Service Campaign Bulletin

Campaign No. 2017030010, July 2017

SUBJECT: **Models 166 and 292, Model Years 2016 and 2017**
Check Roll Stabilization Hydraulic Line

Figure 1

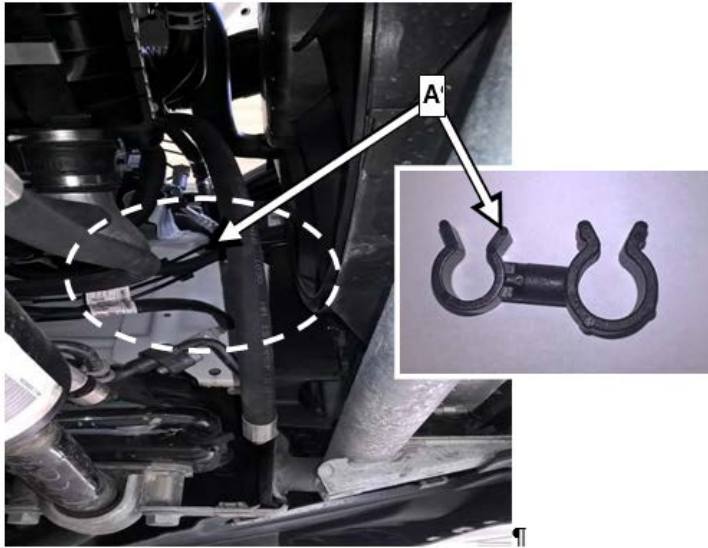
1.  Remove front and center underfloor paneling, refer to WIS: AR61.30-P-1001GQ.
2.  Check whether plastic retaining clips (A, Figure 1) are installed on the hydraulic line of the roll stabilization in the marked area.

**Note:** The clips (A) must be removed and may not be installed again.

Figure 2

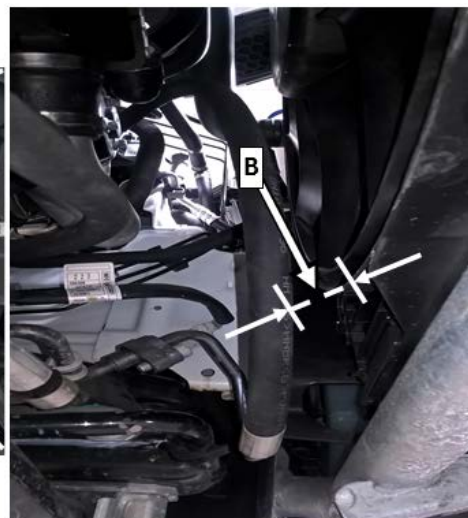
3. Check distance (B, Figure 2) between hydraulic line of roll stabilization and fan.

**Note:** Distance (B, Figure 2) **must be 25 mm**.

- If distance between hydraulic line and fan is **at least 25 mm (OK)**: Procedure is complete.

- If distance between hydraulic line and fan is **too small (NOT OK)**: Proceed to Subject B.
